SEWAGE DISPOSAL SYSTEM

DEPARTMENT OF HEALTH AND MENTAL HYGIENE

P 58053B

SUBDIVISION Greenwood Farms LOT 45 ROAD 7541 Greenwood Drive

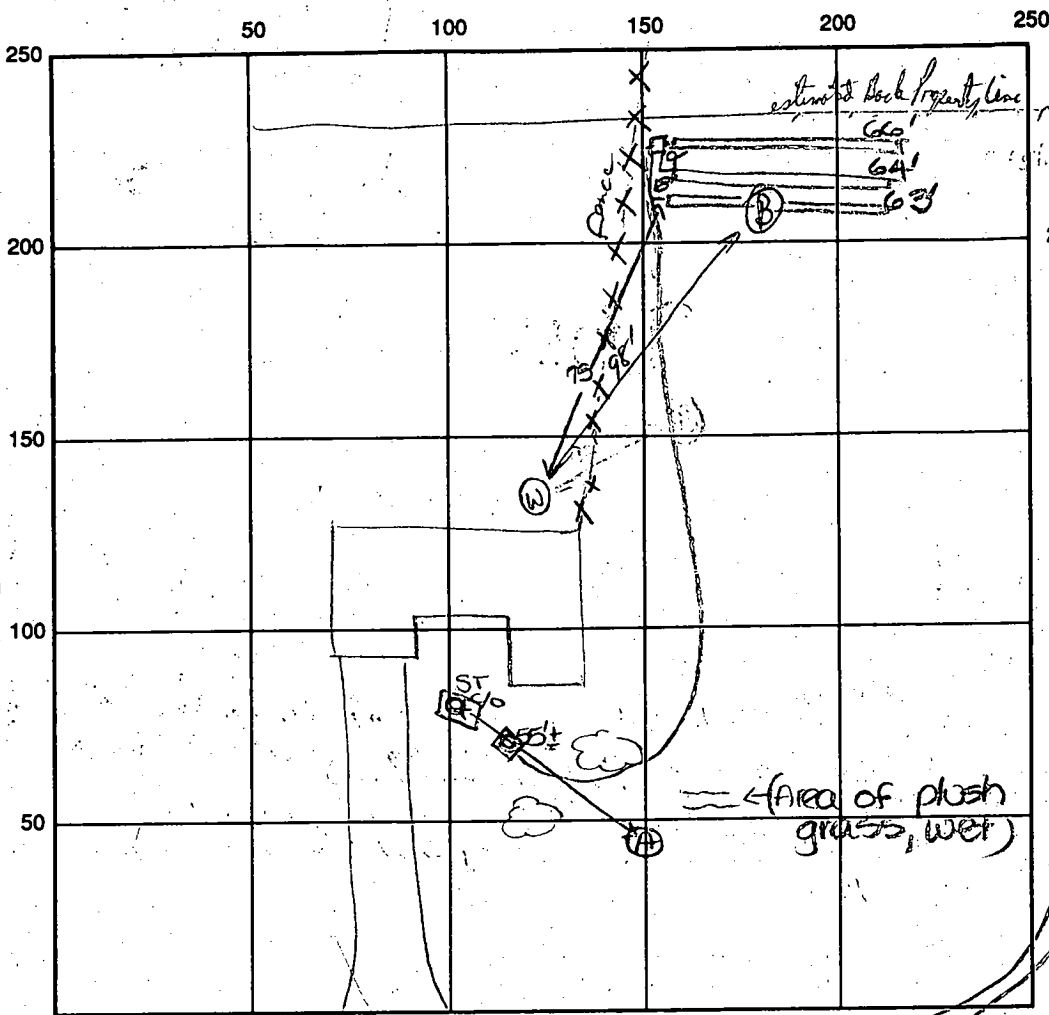
REPAIR - PURPOSE - SEPTIC SYSTEM HAS FAILED
Call for inspection when ground is opened so sanitarian can recommend repair.
03/24/97

Shallow septic repair system only. 3ft wide trenches, 2ft stone fill; Maximum depth
4 1/2 ft, install 125 ft of trench (if 4 or 5 ft trench widths are used -> 375 square
foot of bottom trench or bed is minimum requirement). Install trenches on contour
toward back of property; keep at highest elevation possible and at least 60 ft from owner's well.
Call for open trench inspection before proceeding. JJP 4/18/97

REMARKS: 3/24/97 Perc hole (A) fails. Homeowner not present.
R. Fyock and I were unable to locate well or property markers. No further work done today. DKS
5/5/97 OK to cover trenches and continue. DKS
5/6/97 OK to cover pump pit and line to dist. box. DKS
Pump to be installed 5/10/97 at P11111
 DATE SYSTEM APPROVED 5/16/97 INSPECTOR [Signature]
5/16/97 FINAL INSP - Pump check OK. DKS / KAM
